PRODUCT / PROCESS CHANGE NOTIFICATION

1.1 Company	 STMicroelectronics International N.V
1.2 PCN No.	MDG/23/13886
1.3 Title of PCN	ST Shenzhen (China) TSSOP20 package copper alloy bonding wire introduction on STM32C01x, STM32C03x, STM32G05x and STM32G06x listed products
1.4 Product Category	STM32C01x STM32C03x STM32G05x STM32G06x
1.5 Issue date	2023-01-22

**PRODUCT/PROCESS
CHANGE NOTIFICATION
PCN13886
– Additional information**

**ST Shenzhen (China) TSSOP20 package copper alloy bonding
wire introduction on STM32C01x, STM32C03x, STM32G05x and
STM32G06x listed products**

Standard marking example:

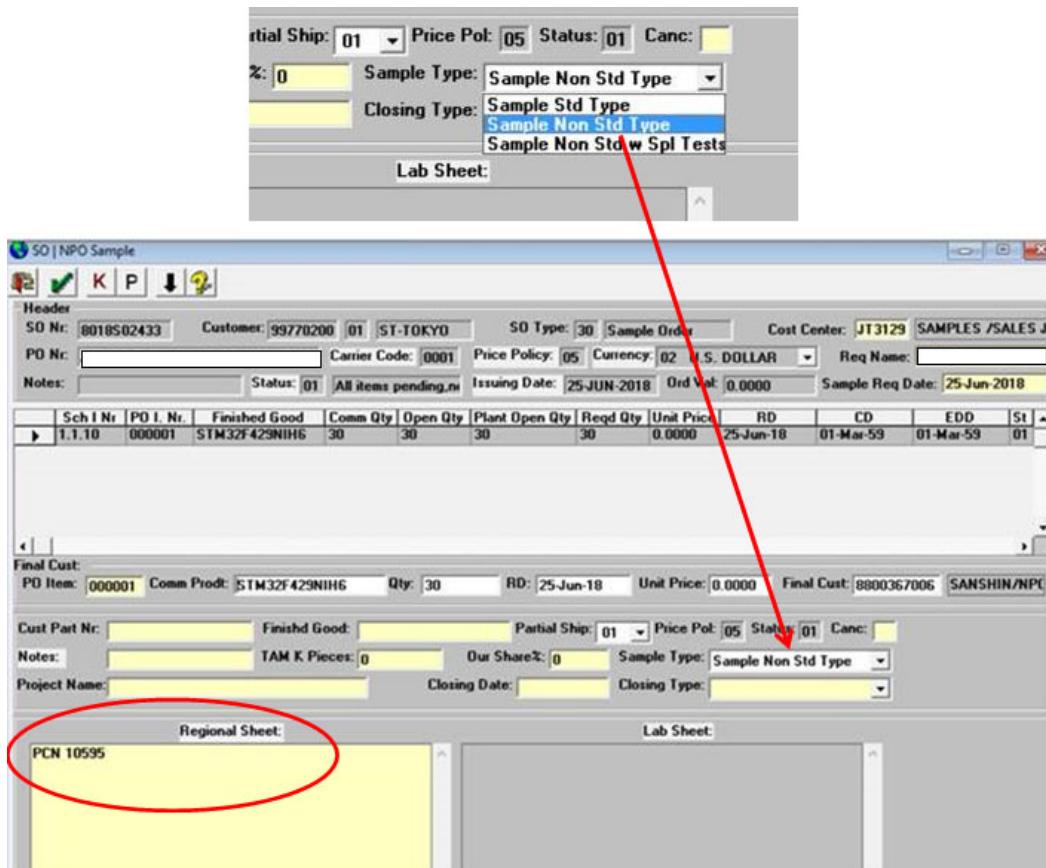
How can the change be seen?

Traceability ensured by ST internal tool.
